UNITED STATES PATENT AND TRADEMARK OFFICE

<p align="center">Office Action Summary</p>	<p>Application No.</p> <p>10/802,519</p>	<p>Applicant(s)</p> <p>ANNAYYA ET AL.</p>	
	<p>Examiner</p> <p>Mujtaba K. Chaudry</p>	<p>Art Unit</p> <p>2133</p>

DETAILED ACTION

FIG. 3A

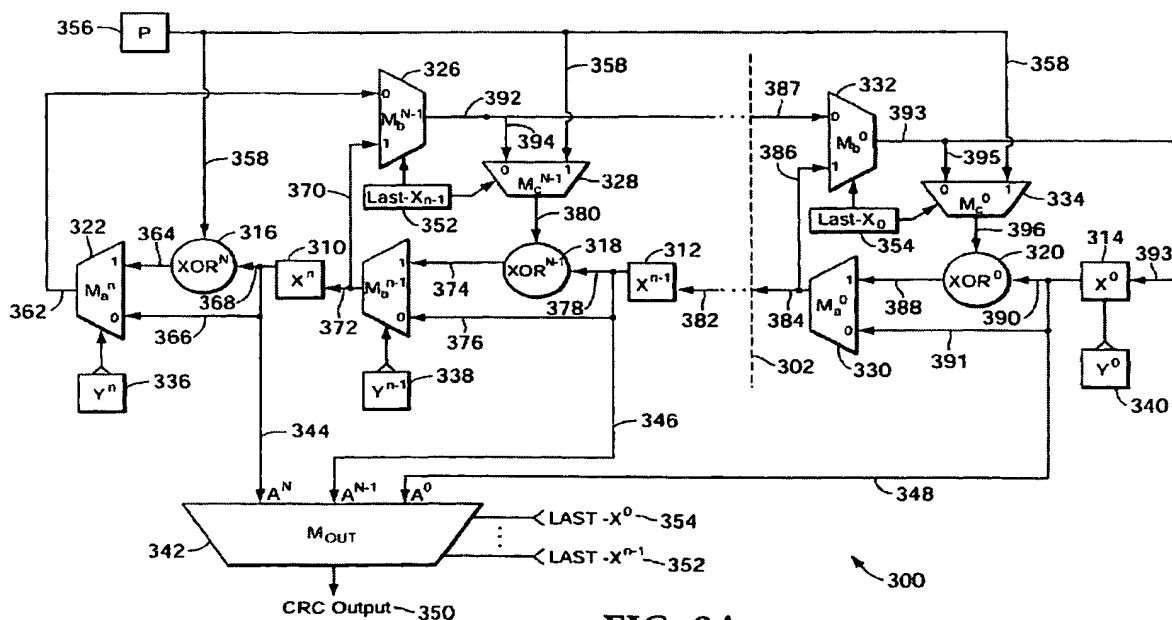
As per claim 1, Chen teaches an apparatus (i.e., title and paragraph 0002) comprising: a cycle redundancy check (CRC) calculator (i.e., Figure 3A and paragraph 0033); and a CRC nullifier coupled to the CRC calculator (i.e., Figure 3A, reference numbers 336, 338 and 340 & paragraphs 0011, 0052-0056). The Examiner would like to explain the interpretation of the CRC nullifier. In paragraph 0011 (lines 9-12), Chen teaches to nullify a subset of the shift registers used in the CRC generator. Further in paragraphs 0052-0056, Chen performs the nullification process by programmable registers Y which are shown in Figure 3A and referred to by reference numbers 336, 338 and 340. Particularly, in paragraph 0055 (lines 5-9) Chen explains the nullifier by determining which of the coefficients take the value of 0.

As per claim 2, Chen teaches, in view of above rejection, the CRC nullifier is one of a plurality of nullifiers (i.e., Figure 3A, reference numbers 336, 338 and 340), each having an output (i.e., Figure 3A, reference numbers 336, 338 and 340 have an output), and wherein the apparatus further comprises an output multiplexer (i.e., Figure 3A, reference number 342) coupled to the plurality of CRC nullifiers to select the output of one of the plurality of CRC nullifiers. The Examiner would like to point out that the output multiplexer is coupled to the nullifiers since, for example, the nullifier 338 is connected to control the output 372 and direct it to 310 which then relays it to the output multiplexer 342.

As per claim 3, Chen teaches, in view of above rejections, a data bus having N bytes (i.e., paragraph 0033, lines 2-4) coupled to the CRC calculator, wherein the plurality of CRC nullifiers comprise N-1 CRC nullifiers (i.e., Figure 3A, Y_0 to Y_{n-1} nullifiers).

As per claim 4, Chen teaches, in view of above rejections, a first multiplexer coupled to the CRC calculator (i.e., Figure 3A, reference number 326); and a second input multiplexer coupled to the CRC calculator (i.e., Figure 3A, reference number 332).

As per claim 5, Chen teaches, in view of above rejections, the first multiplexer (i.e., Figure 3A, reference number 326) is coupled to receive a data byte input signal (the input with reference number 370) and a feed zero signal (the input with reference number 362, which is the feed zero signal).

As per claim 6, Chen teaches, in view of above rejections, the second multiplexer (i.e., Figure 3A, reference number 332) is coupled to receive a default value input signal (input with reference number 387) and a CRC input signal (input with reference number 386).

As per claim 7, Chen teaches, in view of above rejections, the first multiplexer (i.e., Figure 3A, reference number 326) and the CRC calculator (i.e., Figure 3A, reference number 328) are each coupled to receive a byte enable signal (i.e., Figure 3A, reference number 352).

As per claim 8, Chen teaches, in view of above rejections, the CRC calculator performs a closed loop function (i.e., Figure 3A and paragraph 0059) and wherein the plurality of CRC nullifiers perform an operation outside of the closed loop function. The Examiner would like to point out that the nullifiers shown in Figure 3A (336, 338 and 340) operate outside of the closed loop function which only incorporates multiplexers 326, 328 and 324 (i.e., paragraph 0059).

As per claim 13, Chen teaches, in view of above rejections, performing a closed loop calculation function using the CRC calculator (i.e., Figure 3A, reference numbers 324, 326 and 328 and paragraph 0059); and performing a nullification function outside of the closed loop

calculation function using at least one nullifier (i.e., Figure 3A, reference number 338) of a plurality of nullifiers (i.e., Figure 3A, reference numbers 336, 338 and 340). The Examiner would like to point out that the nullification process is outside of the loop comprising of, for example, multiplexers 324, 326 and 328 (i.e., paragraph 0059).

As per claim 14, Chen teaches, in view of above rejections, to perform a closed loop calculation in a first cycle and the nullification is performed in one or more cycles following the first cycle (i.e., Figure 3A and paragraph 0031). The Examiner would like to point out that Chen teaches the ability to program and then reprogram, which means to calculate the CRC in a closed loop (i.e., paragraph 0059) and then reprogram by performing nullification (i.e., paragraphs 0052-0055) in a subsequent cycle.

As per claim 20, Chen teaches, an apparatus (i.e., Figure 3A and paragraph 0002) comprising: means for performing a closed loop calculation function using cycle redundancy check (CRC) calculator (i.e., Figure 3A, reference numbers 324, 326 and 328 and paragraph 0059); and means for performing a nullification function outside of the closed loop calculation function using a nullifier (i.e., Figure 3A, reference numbers 336, 338 and 340 and paragraphs 0052-0055). The Examiner would like to point out that the nullification process is outside of the loop comprising of, for example, multiplexers 324, 326 and 328 (i.e., paragraph 0059). Also, the Examiner would like to explain the interpretation of the CRC nullifier. In paragraph 0011 (lines 9-12), Chen teaches to nullify a subset of the shift registers used in the CRC generator. Further in paragraphs 0052-0056, Chen performs the nullification process by programmable registers Y which are shown in Figure 3A and referred to by reference numbers 336, 338 and 340.
